ARCHITECTURAL ADVISORY COMMITTEE MEMORANDUM

DATE: April 5, 2021 UNFINISHED BUSINESS

SUBJECT: REQUEST BY JAMIE CHISICK, ON BEHALF OF OC COAST, INC., FOR

A MINOR ARCHITECTURAL APPLICATION TO ALTER THE EXTERIOR OF AN EXISTING CANNABIS FACILITY, HIGHTEND, LOCATED AT 3395 NORTH INDIAN CANYON DRIVE, SUITE A (APN: 669-452-063), ZONE C-

Endurance Fin 19-Watt Graphite Outdoor Integrated LED Flood Light, 3000K

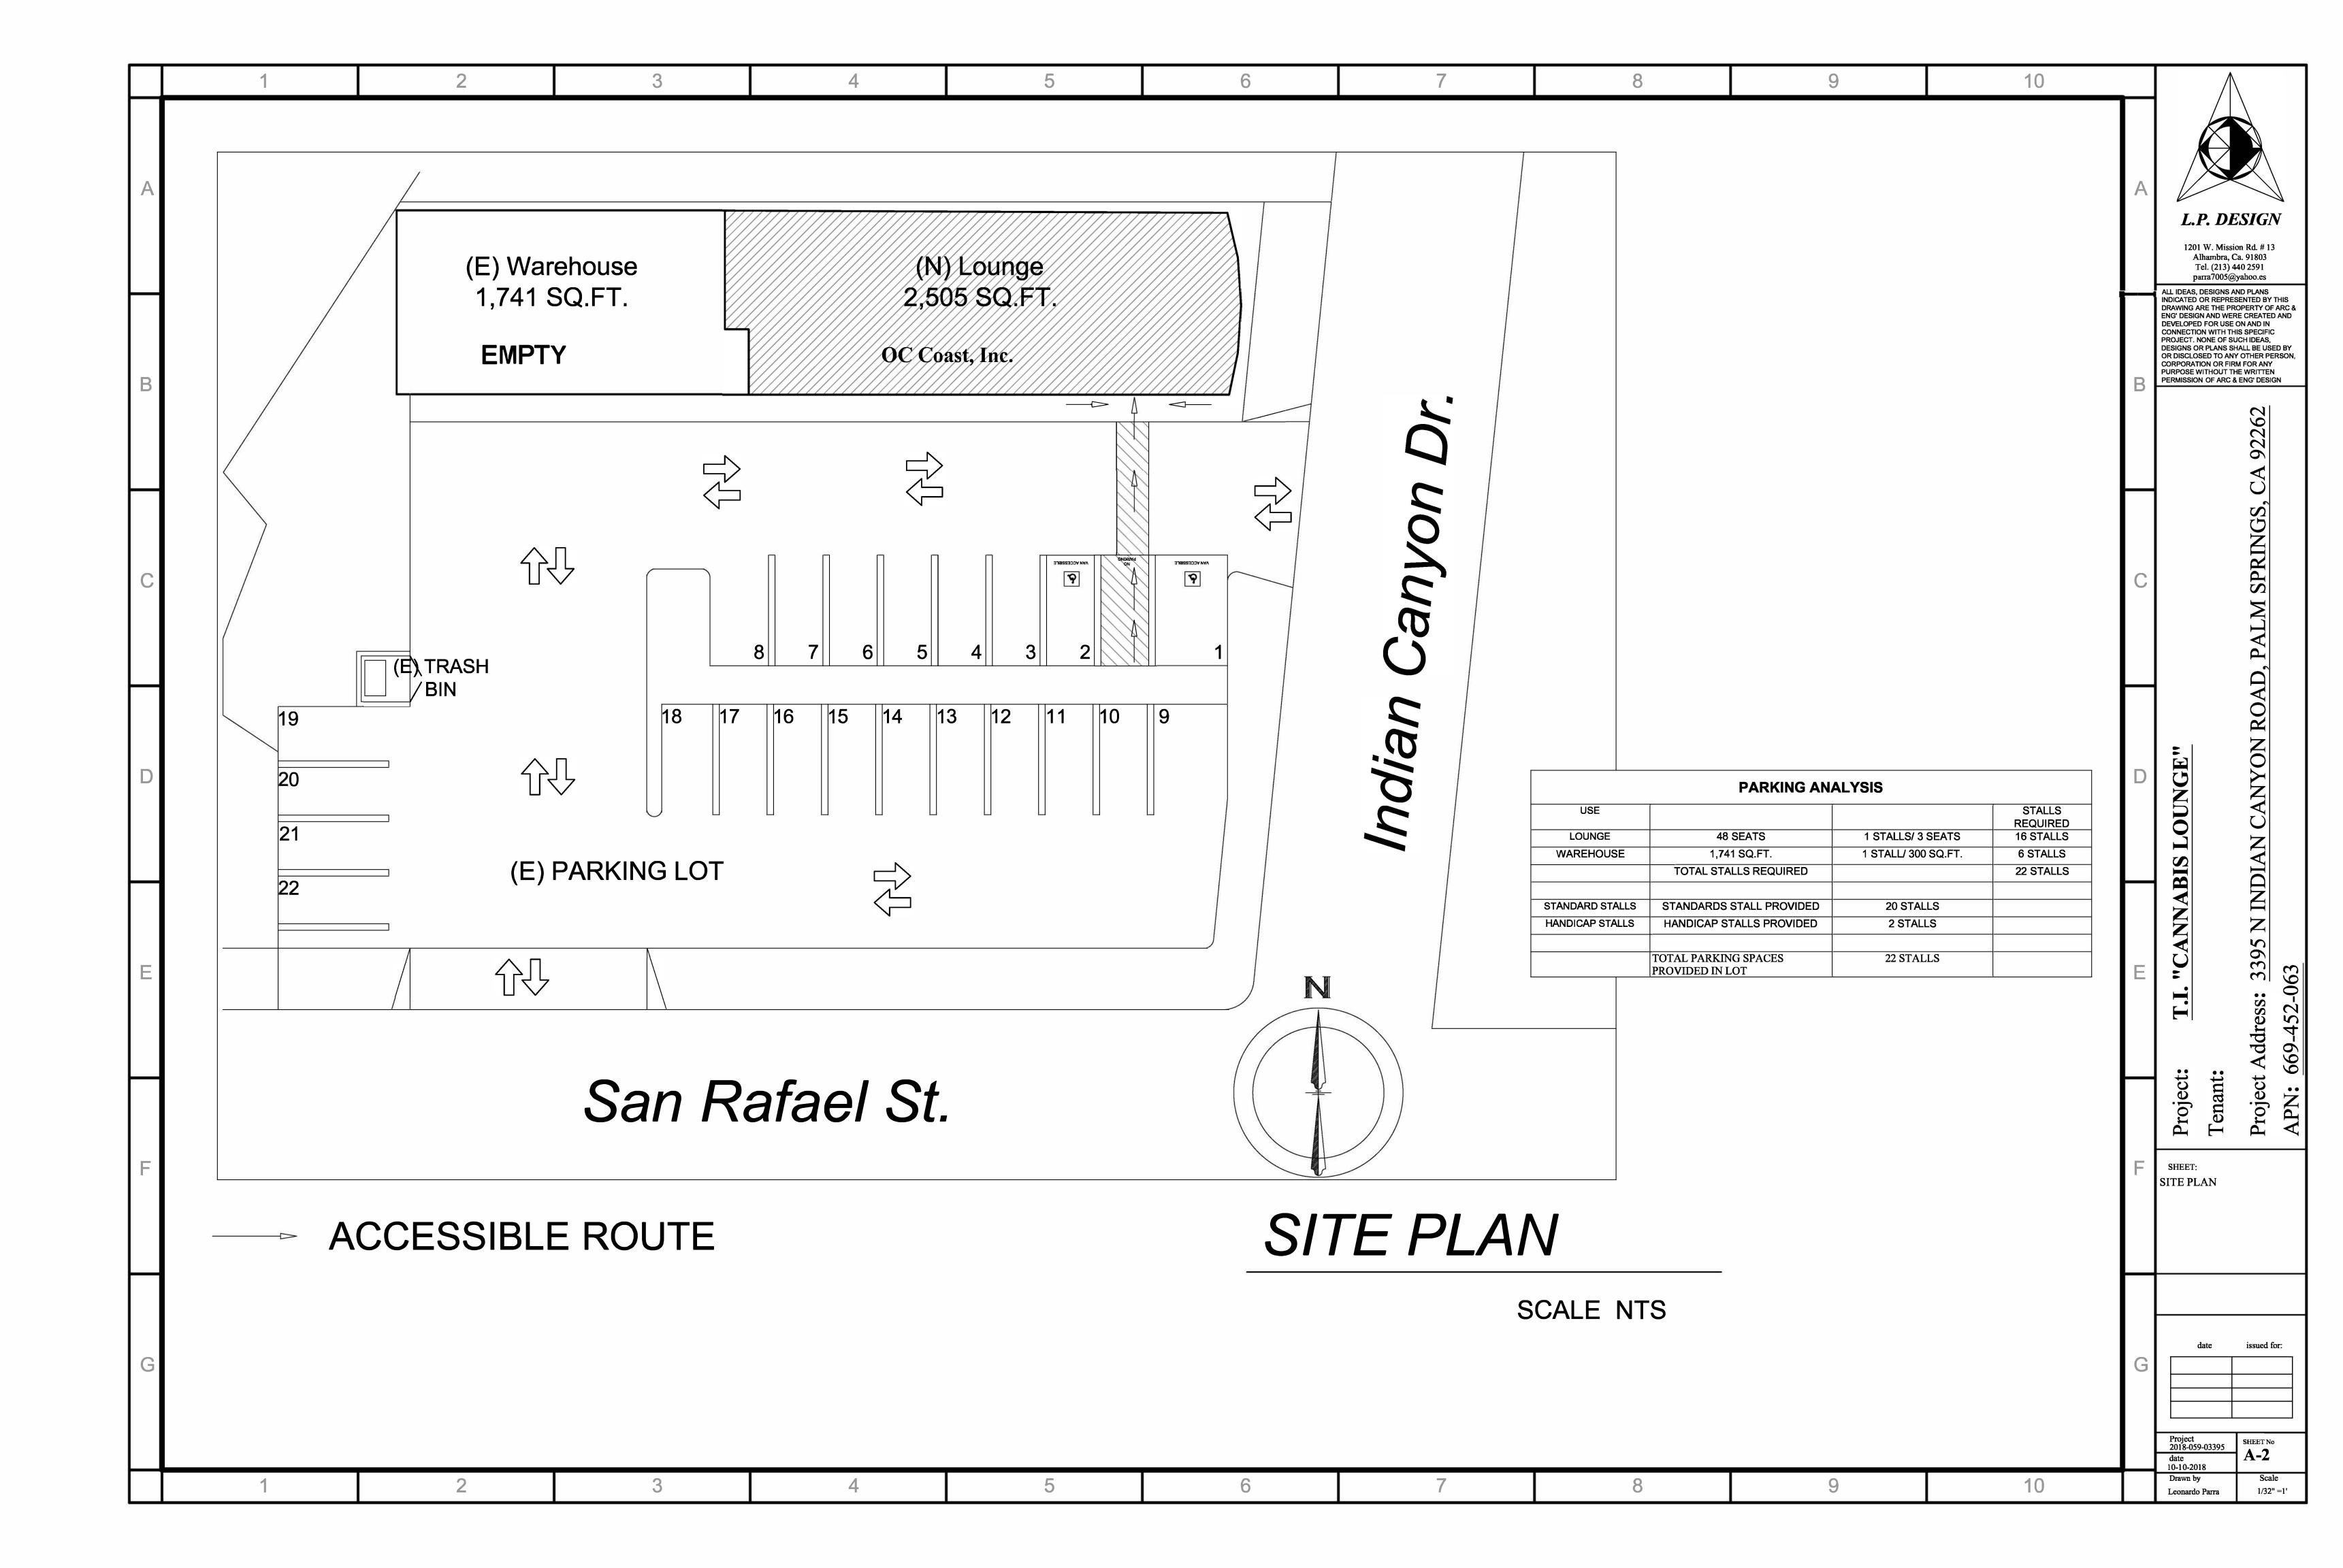
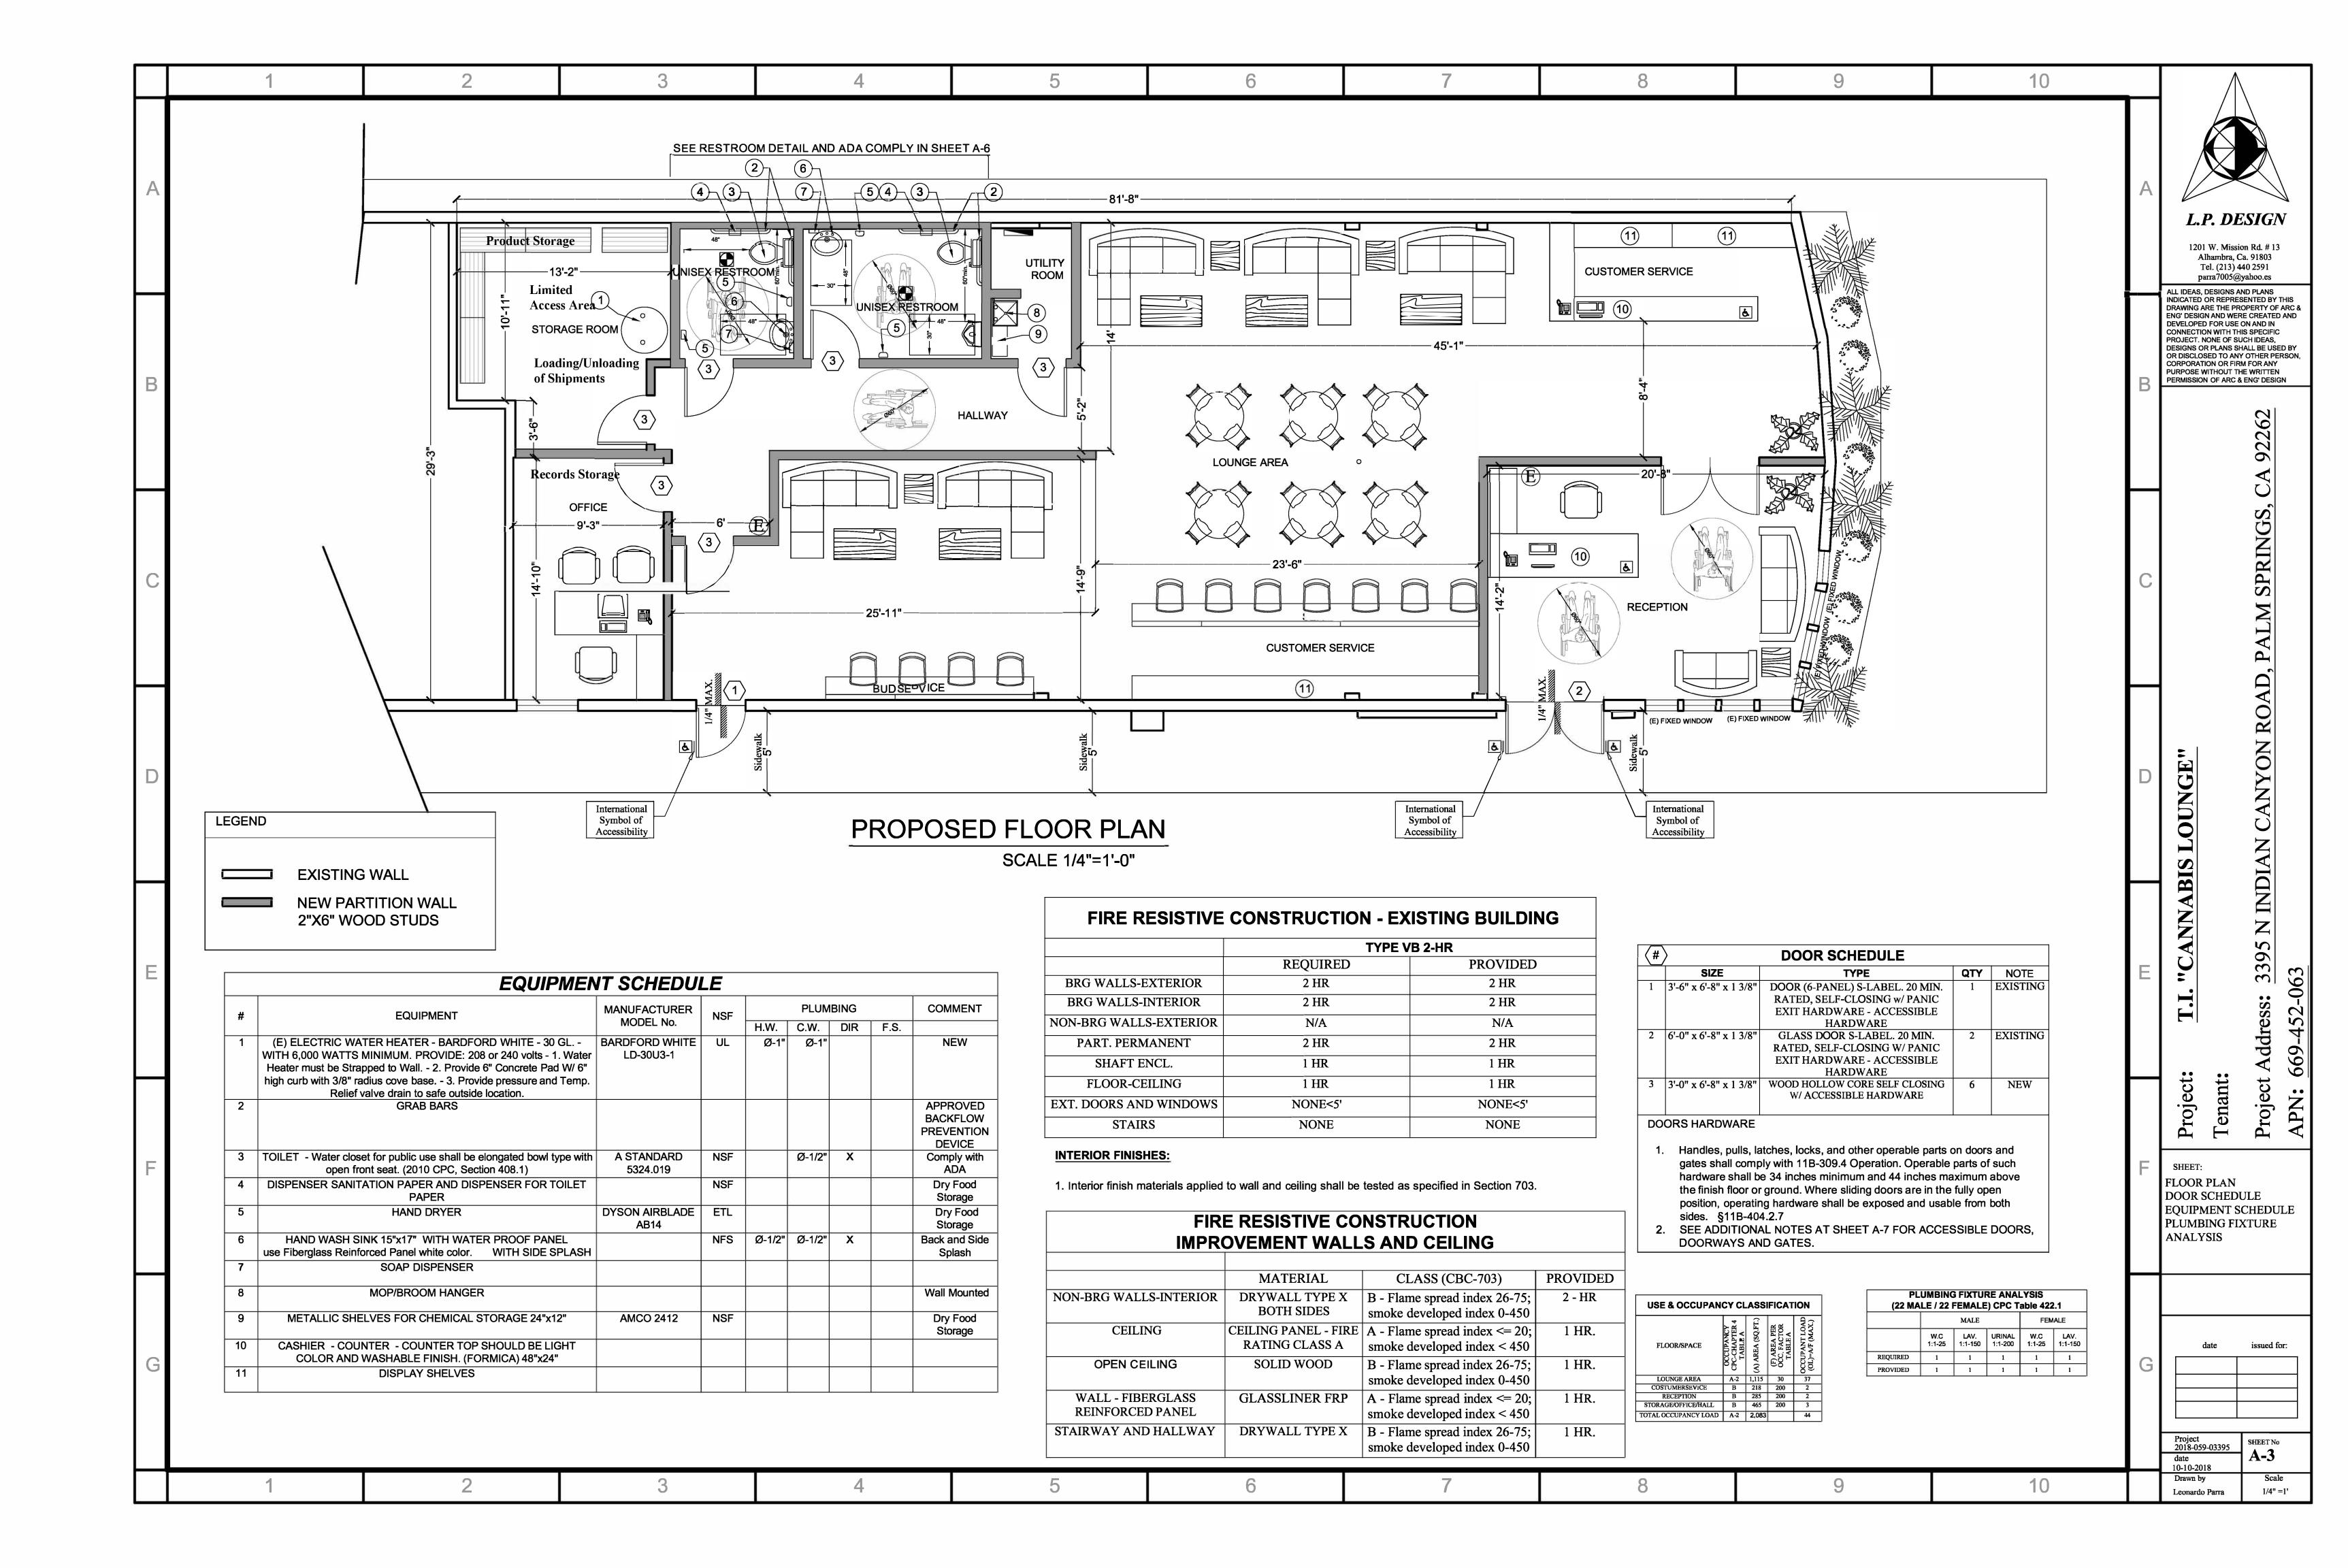
- 1. Use warmer light fixtures (3,000 kelvin).
- 2. Address the color of the roll-up doors and ensure that it is complementary with the rest of the paint scheme. This applies to other details around the façade on the south elevation, including the hinges and trims. The color should match or align with the trim color or something complementary.
- 3. Reduce the quantity of the light fixtures. Light fixtures need to conform to the zoning requirements, including the shielding requirement. Battery-powered light fixtures are discouraged.
- 4. Consider improving the condition of the landscape.
- 5. Future signage should complement the exterior light fixtures.

Vice Chair Rotman is not in favor of the 4k kelvin fixture; he suggested 3,500 or even 3,000 kelvin would be more appropriate.

Table 1.1 AAC Comments & Proposed Changes		nanges
	AAC Comments	Proposed Changes
1	Use warmer lighting fixtures (3k kelvin)	Actual color temperature of 3000K is proposed (Attachment #4).
2	Address the color of the roll-up doors and ensure they are complementary with the rest of the paint scheme. This applies to other details around the façade on the south elevation, including the hinges and trims. The color should match or align with the trim color or something complementary.	Minor architectural accents such as the security roll-up shutters and garage doors of the adjacent tenant space will be painted in Dunn-Edwards Anchor Gray for consistency.
3	Reduce the quantity of the light fixtures. Light fixtures need to conform to the zoning requirements, including the shielding requirement. Battery-powered light fixtures are discouraged.	,

PLANTING PLAN

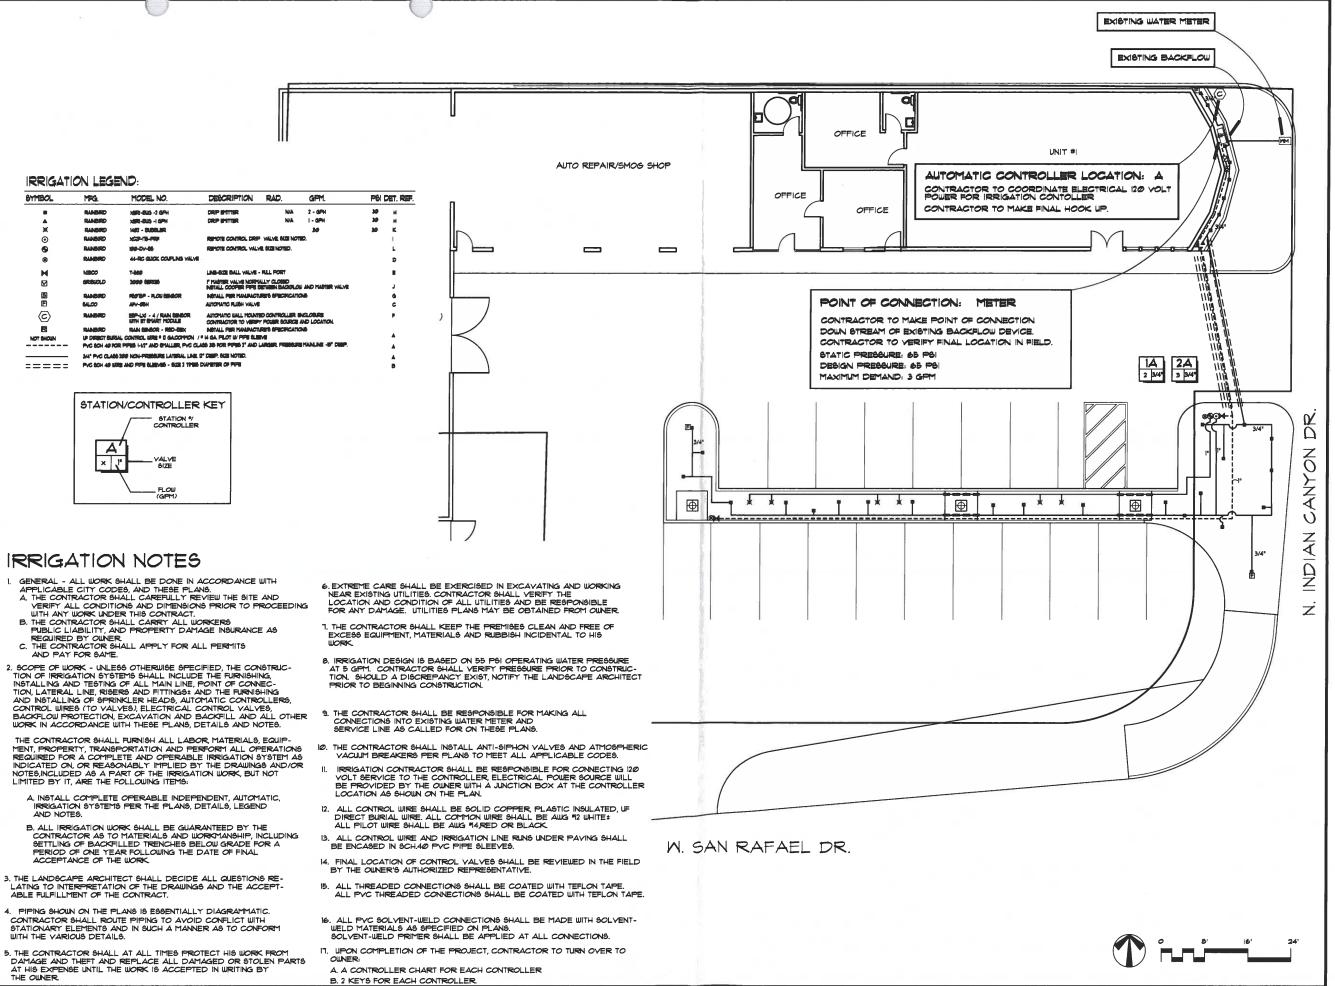
Tab	Table 1.1 AAC Comments & Proposed Changes	
	AAC Comments	Proposed Changes
		on the south/primary elevation and 2 on the east elevation).
4	Consider improving the landscape.	There is an approved landscape plan for the property (Attachment #7). According to a site inspection conducted by staff, one of the trees is missing, and all groundcovers depicted on the plan are non-existent. The applicant is a lessee and is not the owner of the property. The matter has been forwarded to the Code Compliance Division to ensure that the site's landscape is installed and maintained according to the approved landscape plan.
5	Future signage should complement the exterior light fixtures.	Sign Permit application has not been submitted as a part of this application.

The revised plan addresses the design concerns which were raised by the AAC as summarized in Table 1.1 above. The site's landscape is subject to a landscape plan which was approved on January 7, 2014. Any missing plant materials or inconsistency issues will be addressed via code enforcement. The landscape issue has been forwarded to the City of Palm Springs Code Compliance Division.
